SECTION 00 91 13.01 - ADDENDUM #1

The following provisions replace, revise, and/or add to the drawings and specifications titled "Howell Community Park: Site Improvements" dated "June 21, 2016. The contractor shall acknowledge said provisions by recognizing receipt of this Addendum on page I of the Louisiana Uniform Public Work Bid Form.

DRAWN	JAB
CHECKED	SMH
ISSUED DATE	6-21-2016
ISSUED FOR	BID
PROJECT NO.	16-111
FILE	16-111 C-2 Grading Plan
SHEET	C-2.2

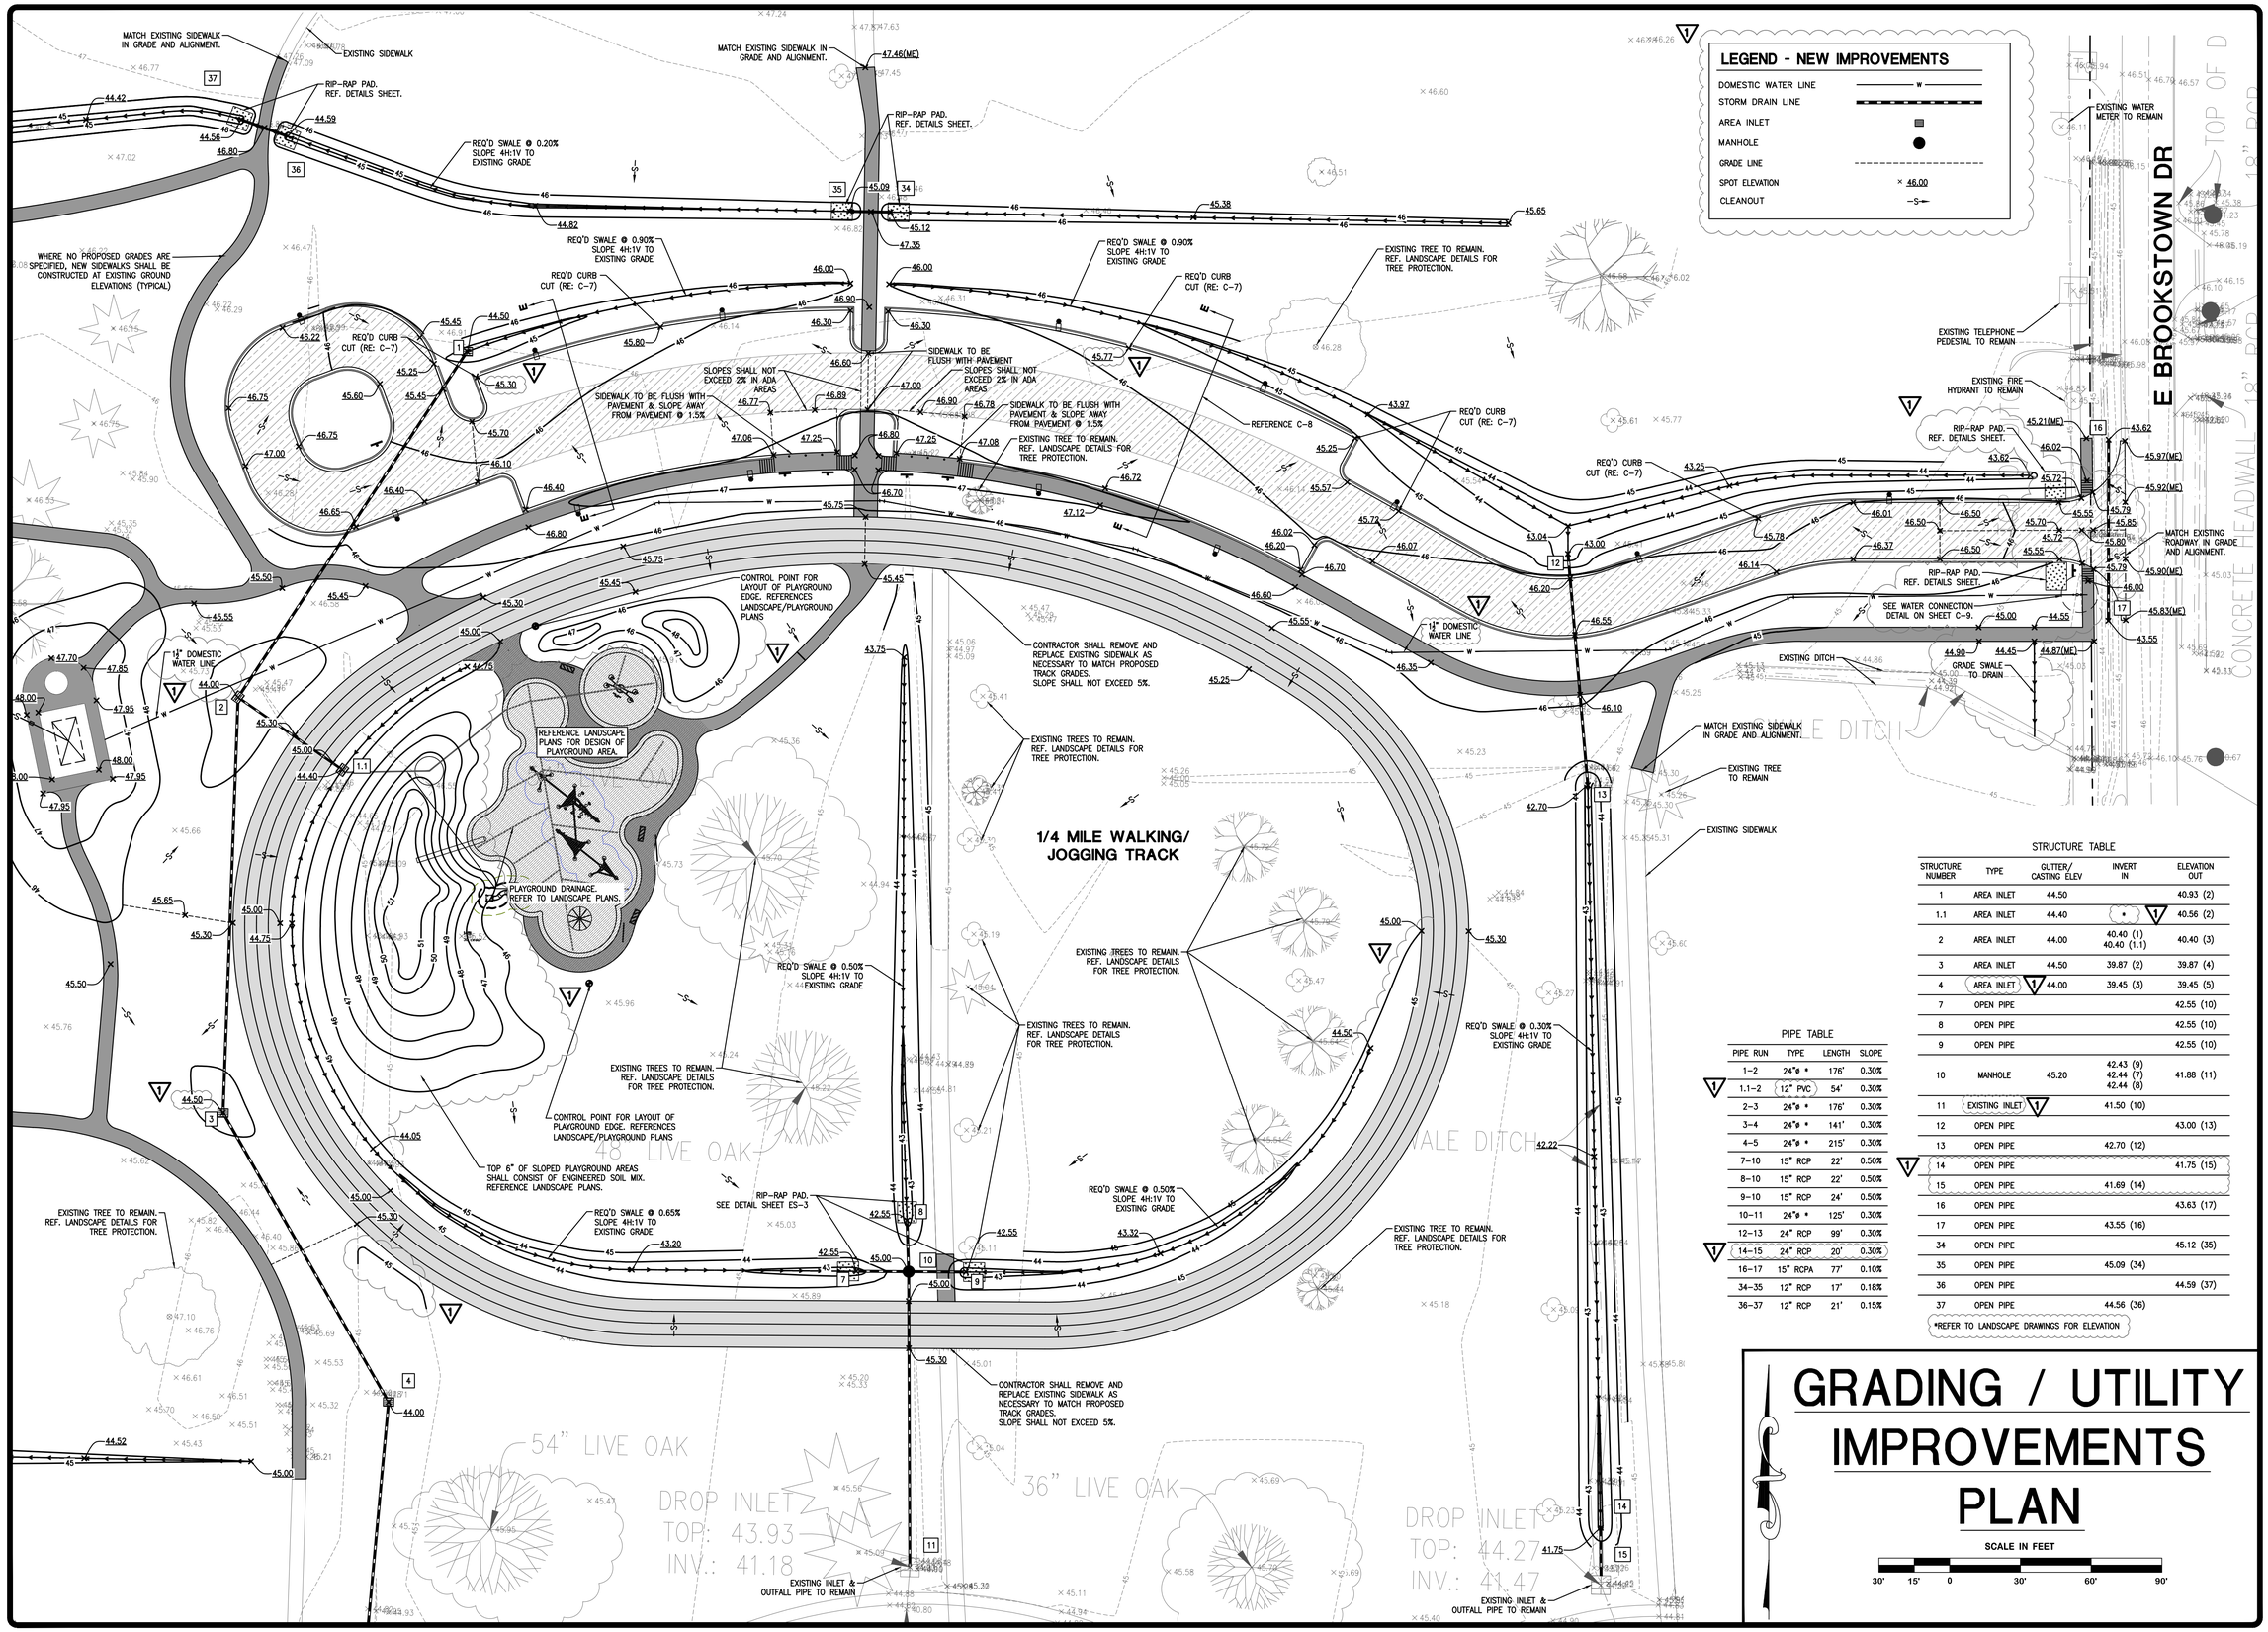
9. C-2.2 Grading/Utility Improvements Plan
    a. Revised contours at playground areas.
    b. Specified 1-1/2” domestic water line.
    c. Added “45” contour north of structure 4.
    d. Revised spot elevations at structures 2 & 3.
    e. Revised two spot elevations along north side of proposed parking lot.
    f. Revised grades at entry drive & adjacent area along E Brookstown Rd.
    g. Added New Improvements Legend.
    h. Revised “Invert In” elevation for structure 1.1 & added note.
    i. Revised “Type” for structures 4 & 11.
    j. Added structures 14 & 15.
    k. Revised pipe type for run 1.1-2.
    l. Added pipe run 14-15.

DRAWN	JAB
CHECKED	SMH
ISSUED DATE	6-21-2016
ISSUED FOR	BID
PROJECT NO.	16-111
FILE	16-111 C-1 Improvements Plan
SHEET	C-3.1

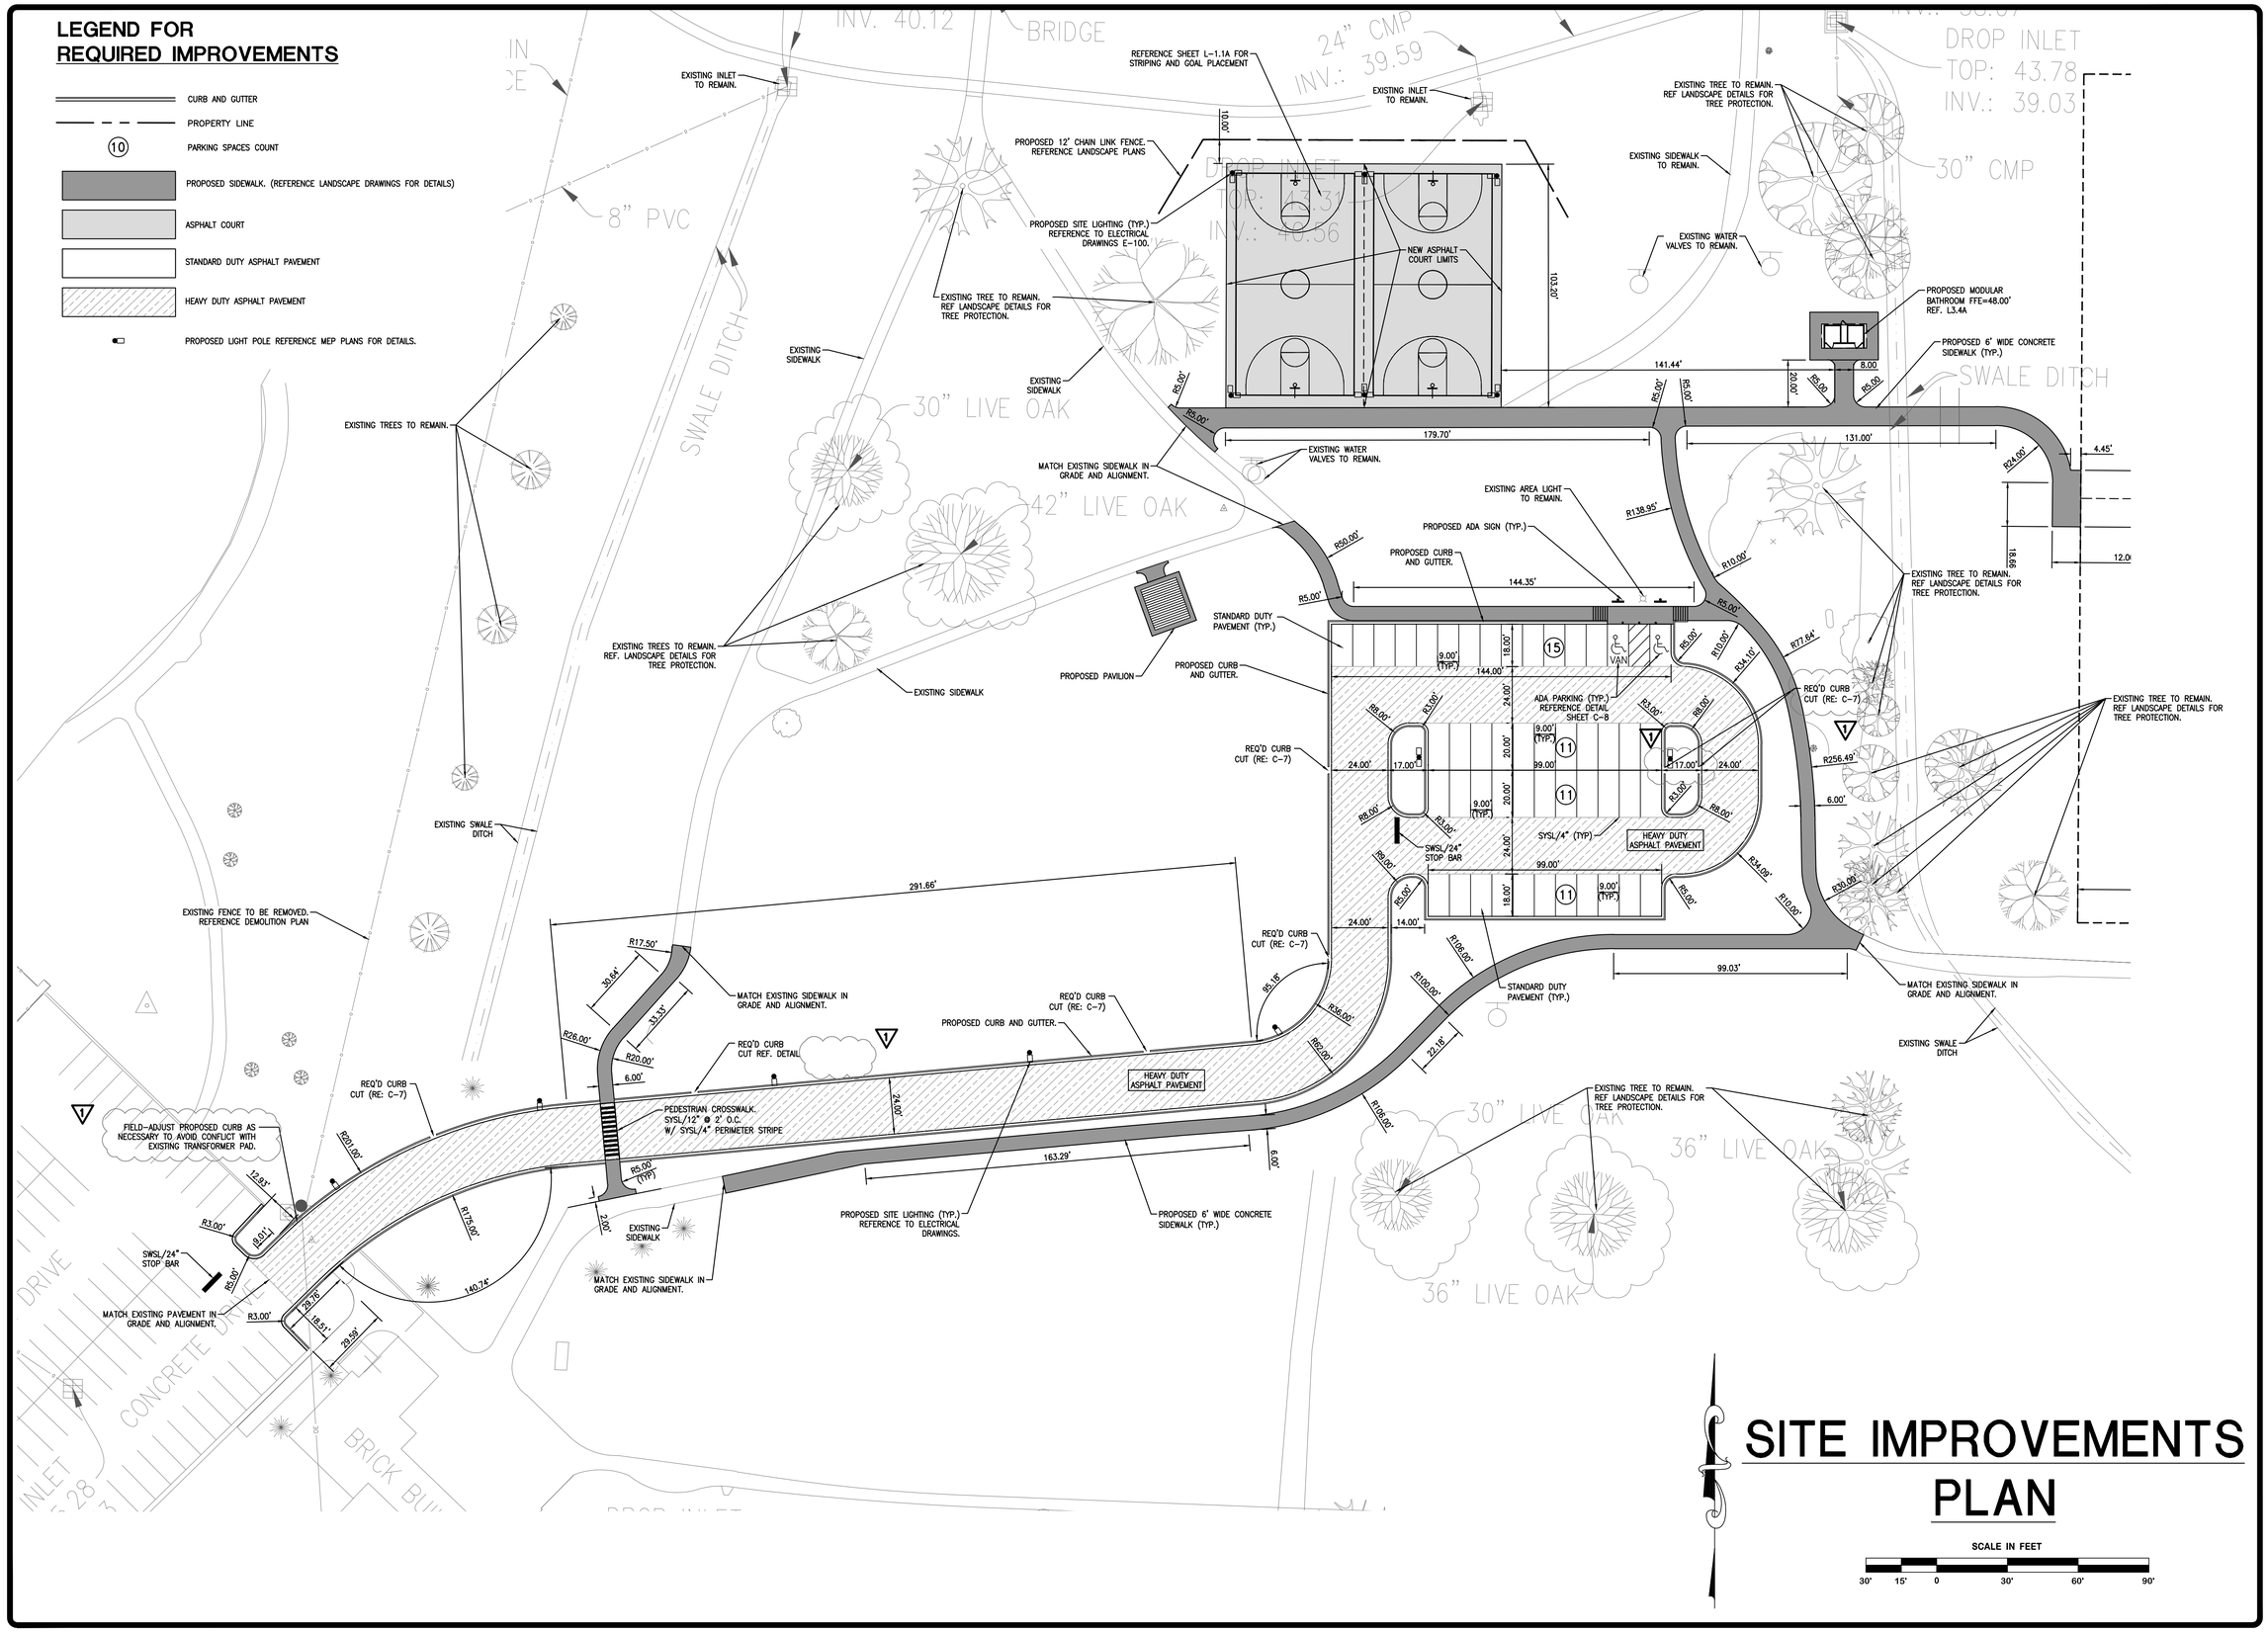
10. C-3.1 Site Improvements Plan
    a. Removed extraneous leader for curb cut that is not required.
    b. Added two (2) curb cuts at island within parking area.
    c. Added note allowing for field adjustment of proposed curb near transformer pad.

DRAWN	JAB
CHECKED	SMH
ISSUED DATE	6-21-2016
ISSUED FOR	BID
PROJECT NO.	16-111
FILE	16-111 C-2 Grading Plan
SHEET	C-3.2

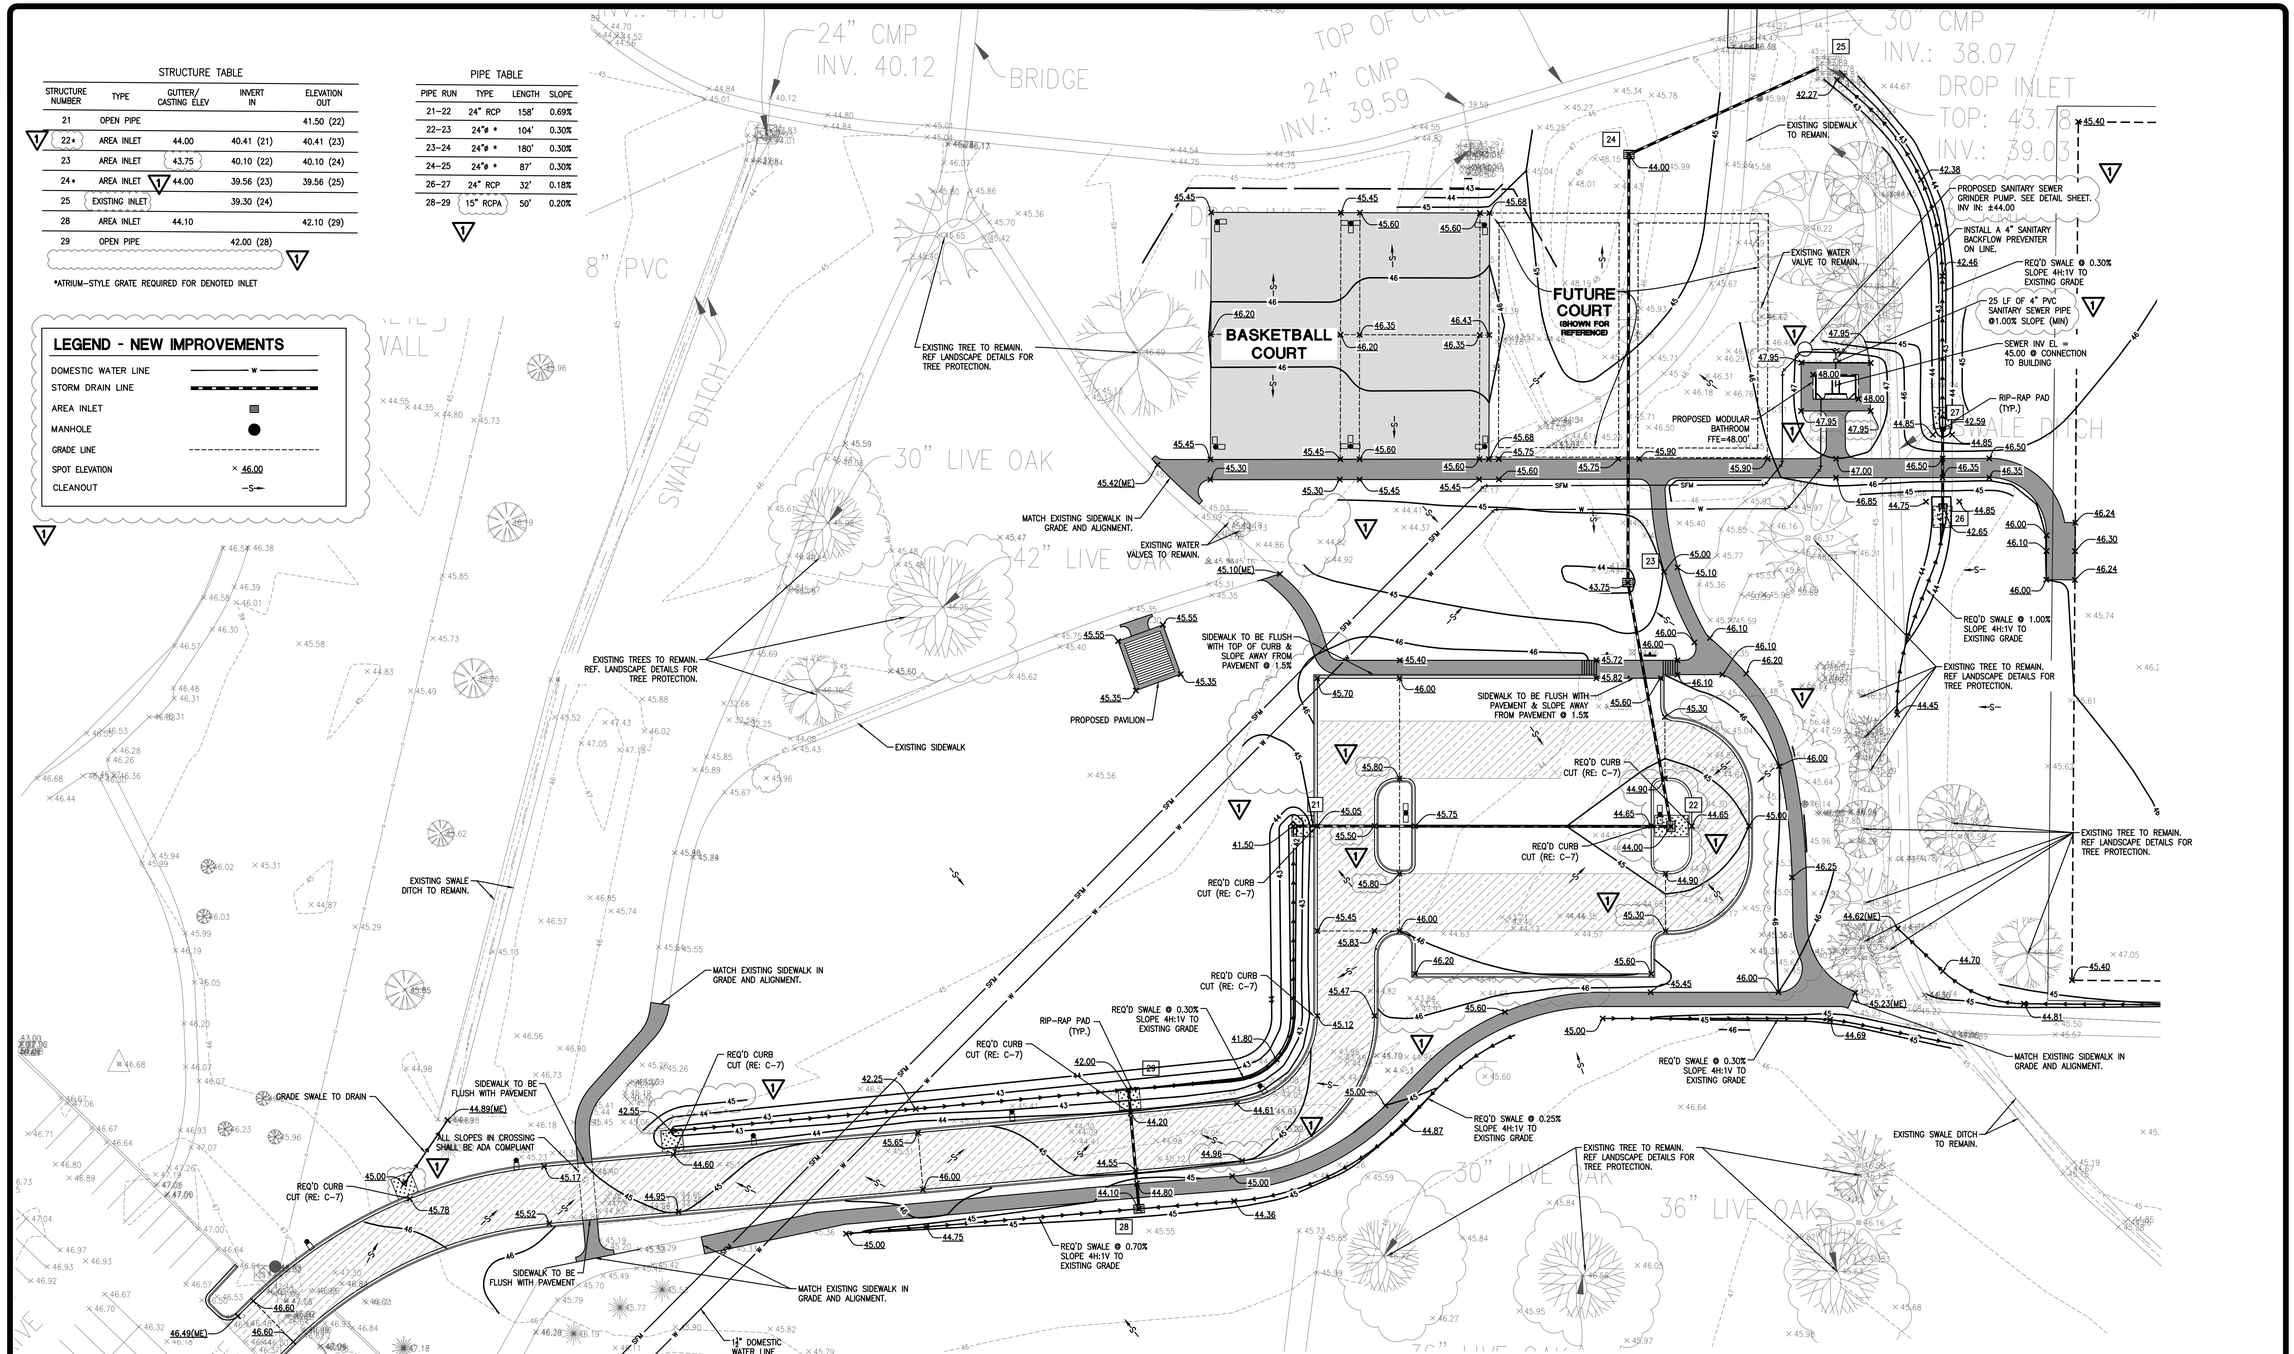
11. C-3.2 Grading/Utility Improvements Plan
    a. Added rip-rap to curb cut along entry drive.
    b. Added “45” contour north of entry drive.
    c. Revised diameter of sewer force main from 2” to 1-1/4”.

d. Revised spot elevation and labeled “45” contour near turn in entry drive.
    e. Revised “46” contour behind parking area.
    f. Revised eight (8) spot elevations within parking area.

g. Revised two (2) spot elevations along propose sidewalk east of parking area, and revised “46” contour adjacent to it.
    h. Revised “45” & “46” contours near northwest corner of parking area.

i. Revised “45” contour between parking area & basketball courts.
    j. Revised spot elevations along sidewalk adjacent to proposed modular restroom.

k. Revised length of sewer pipe from restroom to grinder pump station.
    l. Revised “Invert In” elevation of sewer pipe to grinder pump station.
    m. Added New Improvements Legend.

n. Revised structure 22 to included atrium-style grate.
    o. Revised structure 23 lid elevation to 43.75.
    p. Revised structure 25 type to “Existing Inlet”.

q. Removed structure 31.
    r. Changed pipe run 28-29 to 15” RCPA.
    s. Changed TOC elevation for require sanitary sewer manhole to 49.00.
    t. Revised note referencing existing sewer service connection.
